PD CEN/TS 115-4:2015

Safety of escalators and moving walks

Part 4: Interpretations related to EN 115 family of standards

**Safety of escalators and moving walks - Part 4:
Interpretations related to EN 115 family of standards**

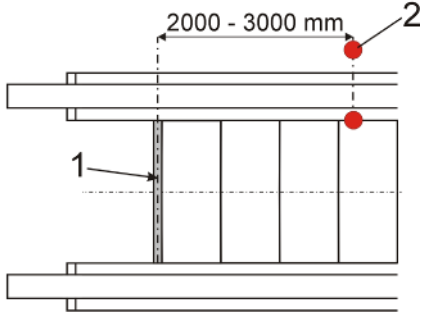
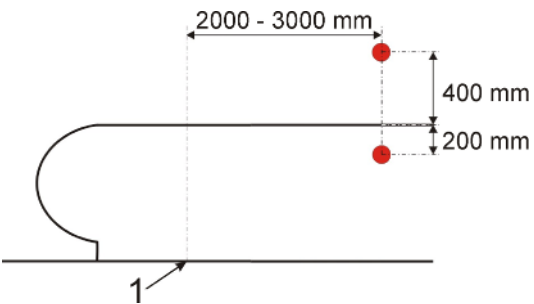
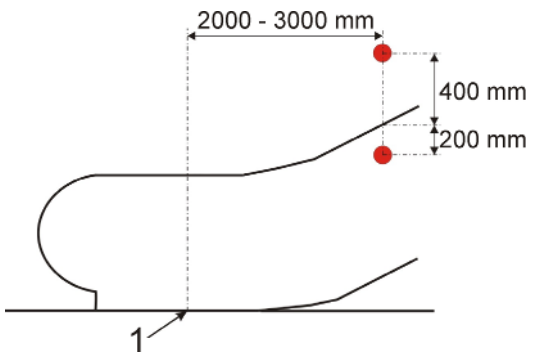
| <p>QUESTION</p> <p>The edge, along the nose line of the steps, has a radius as shown in EN 115-1:2008+A1:2010, Figure 2. The measurement of the maximum allowable gap of 6 mm shown on the drawing is taken at a point below the tread surface where the radius ends.</p> <p>5.3.5 states, "The clearance between two consecutive steps or pallets in any usable position measured at the tread surface shall not exceed 6 mm."</p> <p>Can the committee confirm that location for measurement is as shown on the drawing and the drawing can be considered as a correct interpretation of 5.3.5?</p> | | | |

| <p>INTERPRETATION</p> <p>The measurement shall be carried out as the dimensions of the gaps are indicated in Figure 2. For pallets, the measurements have to be done according Figures 6 and 7.</p> <p>This will be considered in the next revision of EN 115-1.</p> | | | |

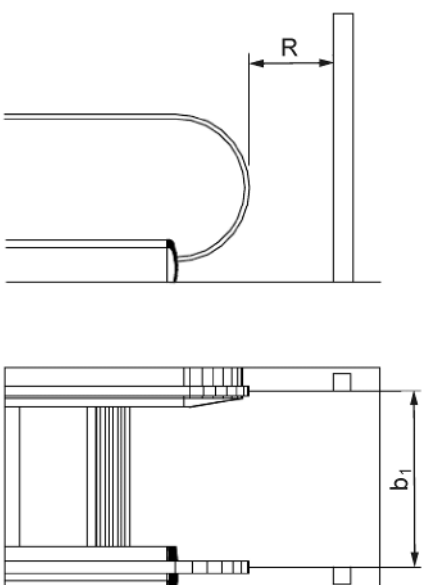
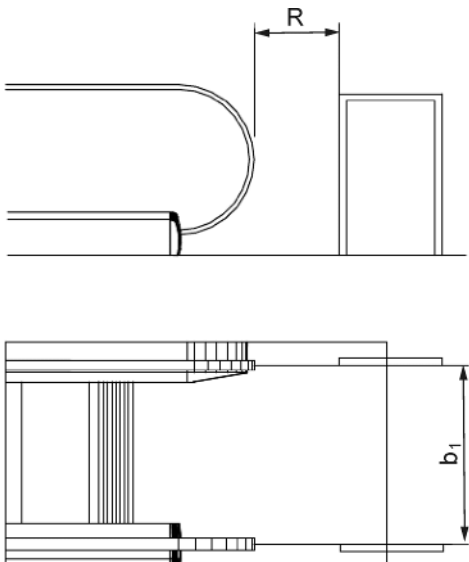
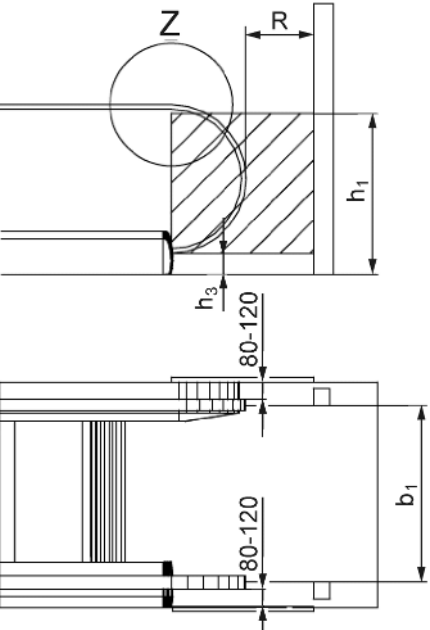
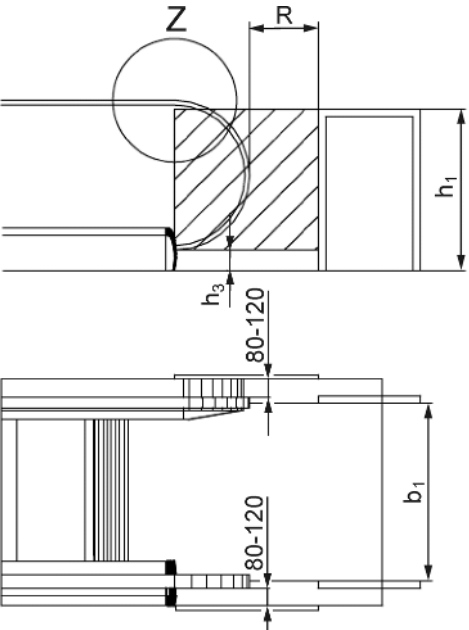
| <p>QUESTION</p> <p>Table 6 h) including A.2.5, requires monitoring of:</p> <ul style="list-style-type: none"> - stopping of succeeding escalators/moving walks; - exits blocked by structural measures <p>Under these conditions, the exit is not described in detail. Is there a defined space which can be considered as an exit?</p> | | | |

| <p>INTERPRETATION</p> <p>In A.2.5, the area of the exit is defined as being the unrestricted area with the minimum (sufficient) values. This definition has to be applied for all conditions.</p> | | | |

| CEN | INTERPRETATION | 117 Page 2 of 2 |
|---|----------------|--------------------|
|  <p style="text-align: center;">Figure 1</p> | | |

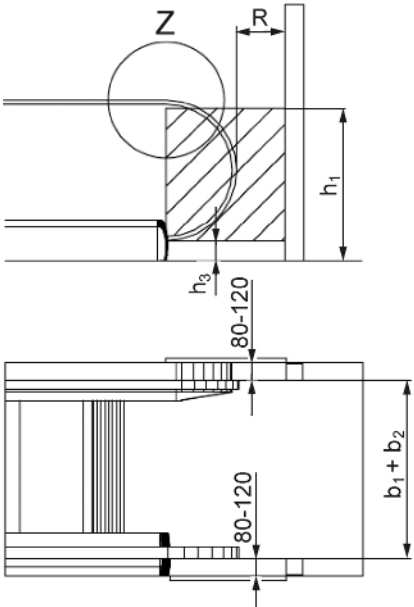
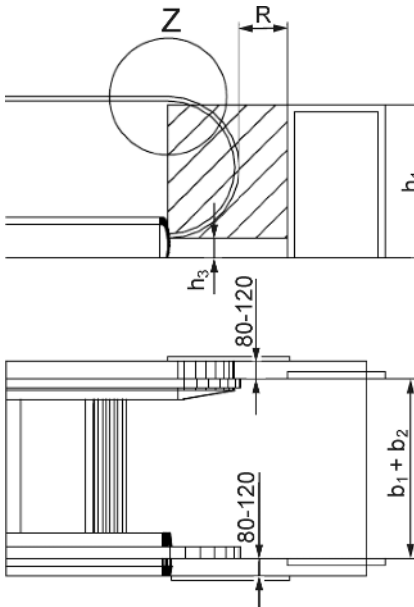
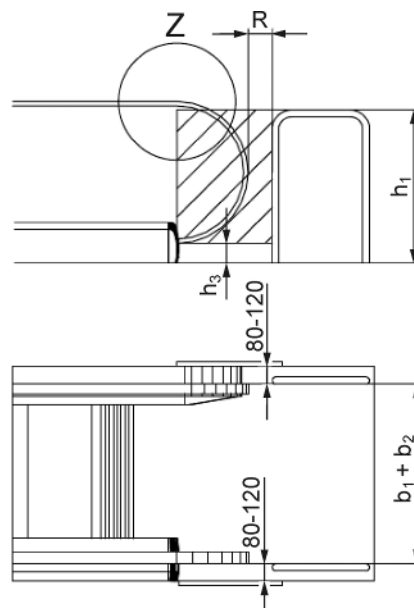
| <p>QUESTION</p> <ul style="list-style-type: none"> - What are the definition of the term “at handrail level” and the position of the stop button? - Is this requirement related to the stop button or to the entire installation (e.g. including housing)? - Are installations slightly above or below the handrail permitted, avoiding hidden installation or conflict with installations close to the handrail? <p>The intention of this requirement is quite clearly defined in A.2.5. A more precise specification of the requirements related to handrail and stop switch or stop switch housing would be appreciated.</p> | | | |

| <p>INTERPRETATION</p> <ul style="list-style-type: none"> - The intention of the wording “at handrail level” is to point out an installation of the stop switch close to the handrails within the reach for the passengers with a distance from the comb intersection line in the range of 2 000 to 3 000 mm (see Figure 1 below). - The installation can be regarded within a vertical range of 200 mm below and 400 mm above the handrails (see Figures 2 and 3 below). Within that range, the stop button can be considered as “not hidden”. - Assemblies in the inside of the balustrade are permitted when they are arranged and formed in such a manner as to eliminate any risk of harm caused by trapping. - The vertical limitations are related to the middle of the actuator (e.g. push button or handle). | | | |

Figure 6 a) — Detail to h_3

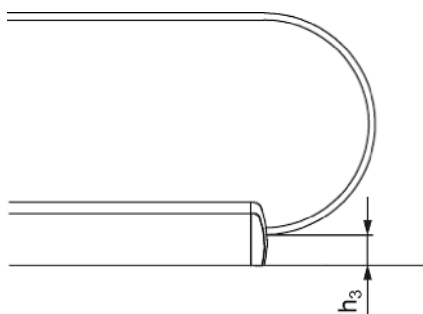
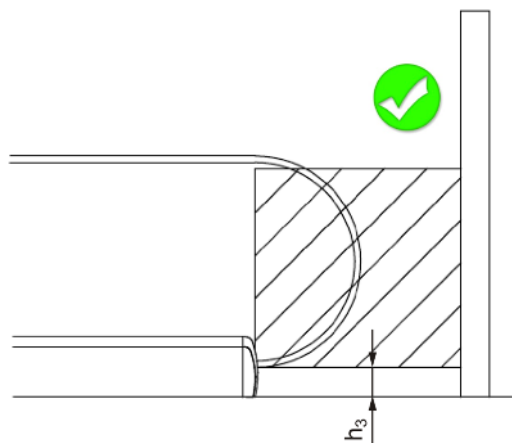
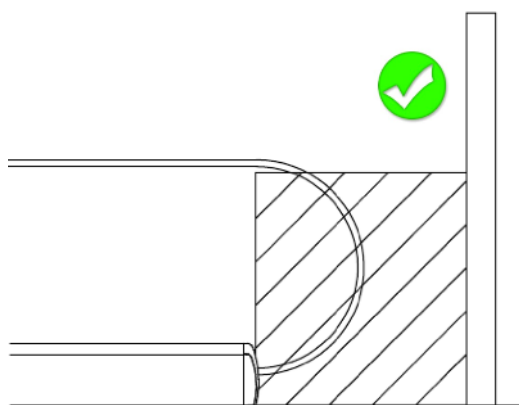
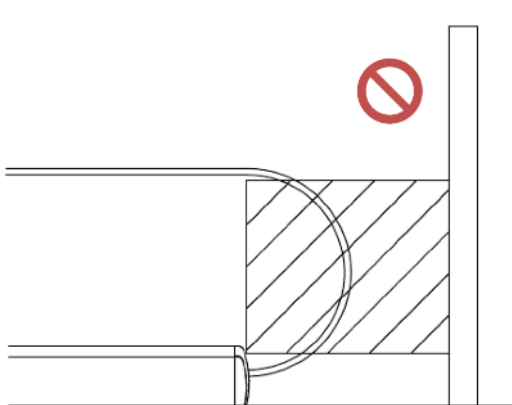
| QUESTION Fixed devices like guiding barriers for improving the traffic flow or traffic columns, especially in the unrestricted area, are not clearly defined in EN 115-1. What are the requirements on these devices? | | | |

| CEN | INTERPRETATION | 119 Page 2 of 7 |
|---|----------------|--------------------|
| <p>C) Further reduction to 180 mm is permitted, as long as the guiding barrier or traffic column is positioned outside of the outer edge of the handrail and an additional barrier is installed between the guiding barrier or traffic column and the vertical centre line of the balustrade newel (see Figures 3 a)/b) on Page 4, Figure 8 on Page 7).</p> <p>The additional barrier shall have a lateral distance between 80 mm to 120 mm of the handrail outer edge and shall close at least the area between the actual lowest point of handrail entry into the newel (h_3) and the balustrade decking profile and shall have filled inlets with gaps < 25 mm with no pinching risk (see Figures 6 a)/b)/c)/d) on Page 5).</p> <p>D) A reduction of the horizontal distance to 100 mm (identical to the minimum value of h_3) is permitted, only if the guiding barrier or traffic column is of a round shape and is positioned outside of the outer edge of the handrail and an additional barrier is installed between the guiding barrier or traffic column and the vertical centre line of the balustrade newel (see Figures 4 a)/b) on Page 4, Figure 8 on Page 7).</p> <p>The additional barrier shall have a lateral distance between 80 mm to 120 mm of the handrail outer edge and shall close at least the area between the actual lowest point of handrail entry into the newel (h_3) and the balustrade decking profile and shall have filled inlets with gaps < 25 mm with no pinching risk (see Figures 6 a)/b)/c)/d) on Page 5).</p> <p>3 Traffic columns requirements</p> <p>The height of traffic columns shall be at least the height of the handrail level.</p> <p>4 Guiding barriers requirements</p> <p>The height of guiding barriers shall be at least the height of the balustrade decking, that is at least the vertical distance between floor level and the upper edge of moving handrail minus thickness of the moving handrail minus at least 25 mm (see b_{12}, A.2.2 of EN 115-1:2008+A1:2010).</p> <p>5 Additional requirements</p> <p>An arrangement of guiding barriers or traffic columns completely outside of the unrestricted area is not subject of this interpretation. The safety distances according to EN 349 shall be respected.</p> <p>If fixed devices are placed inside the unrestricted area, the size of the unrestricted area shall remain the same and in this case be extended in the length (see Figure 7 a)/b) on Page 6).</p> <p>Respect the minimum widths of crossing escape and rescue routes. Local legislations may apply.</p> <p>Building barriers and traffic columns are not considered as structural measures that block the exit.</p> <p>6 Annex: Illustrations</p> <p>See Figures 1 to 8 below.</p> | | |

The lower edge of the additional barriers may be at floor level or at the actual lowest point of the handrail entry into the newel.

Figure 1

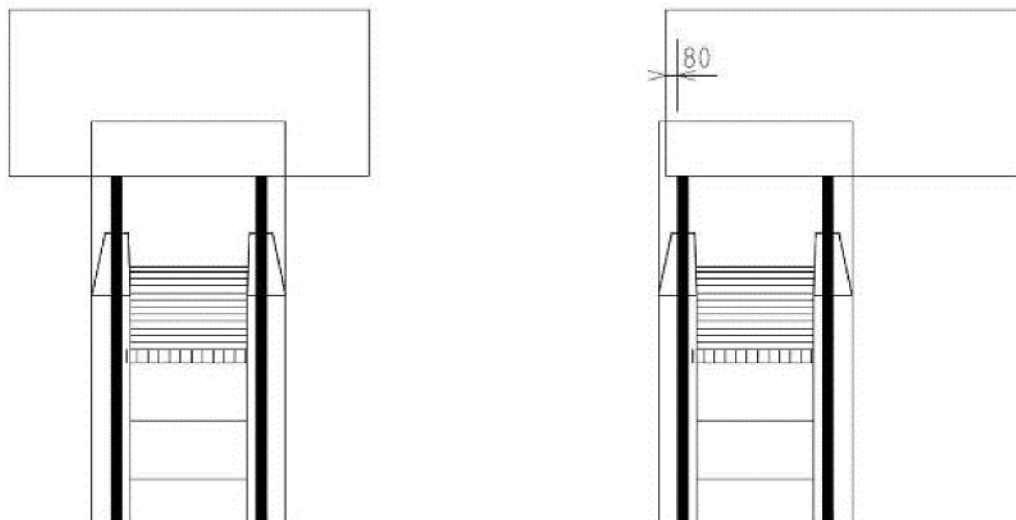
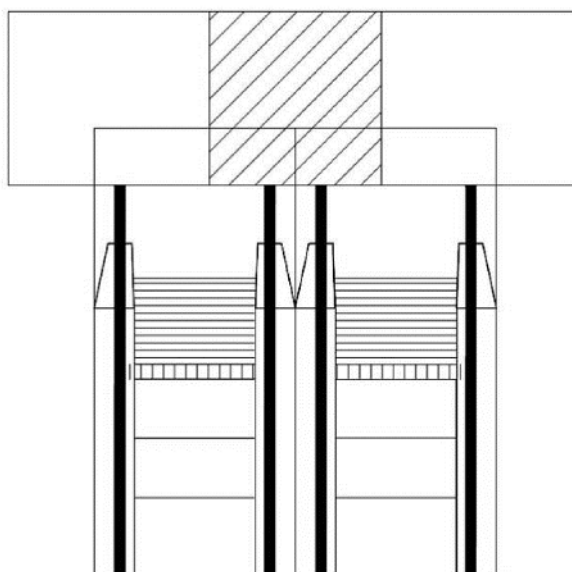
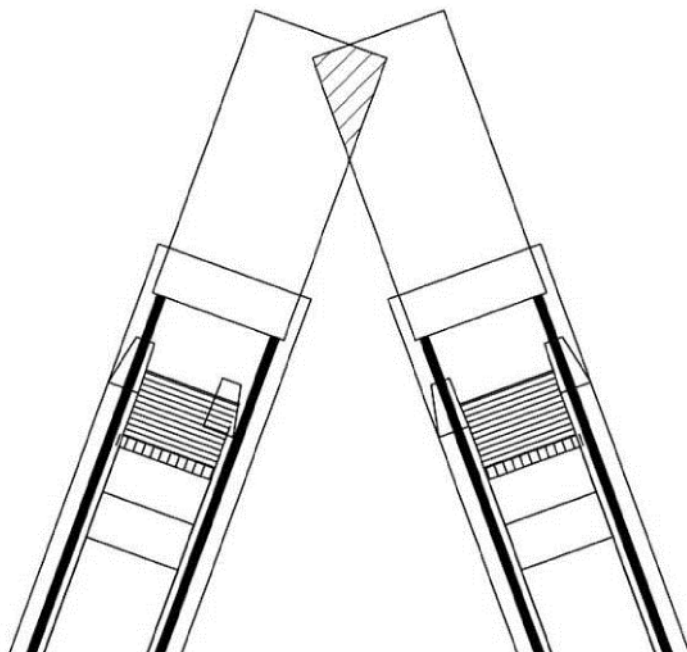
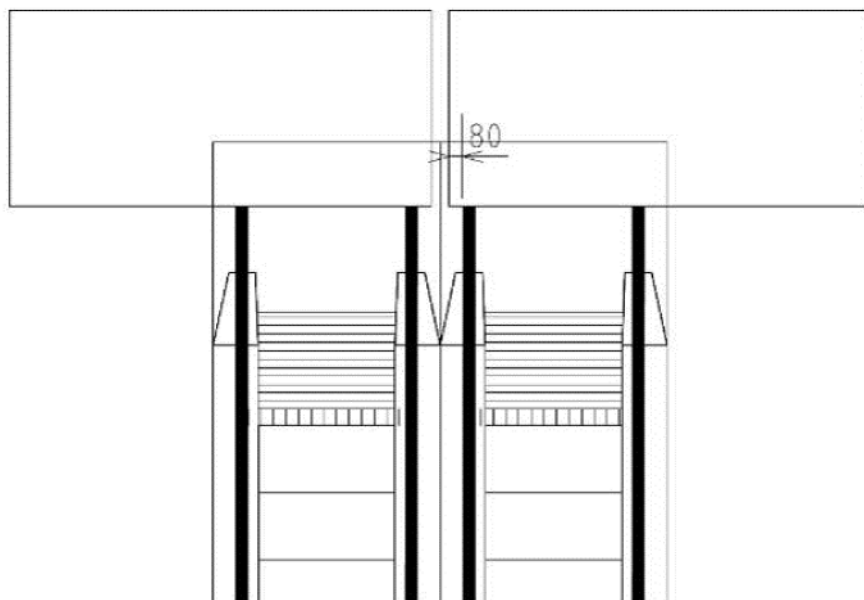
| <p>QUESTION</p> <p>1. In case of a depth reduced to 2 m, is it possible to shift laterally the unrestricted area from the centre line of the escalators/moving walk (see Figure 1)?</p> <p>2. In case of 2 adjacent units with reduced depth of their unrestricted areas, (parallel or scissor configuration) is it allowed to</p> <ul style="list-style-type: none"> • superimpose their two areas? • shift laterally the area(s)? <p>(See Figures 2 to 4).</p> | | | |

| <p>INTERPRETATION</p> <p>1. A lateral shift of the unrestricted area is permitted.</p> <p>2. An overlapping of unrestricted areas is not permitted.</p> <p>This will be taken into account in the next revision of the standard.</p> | | | |
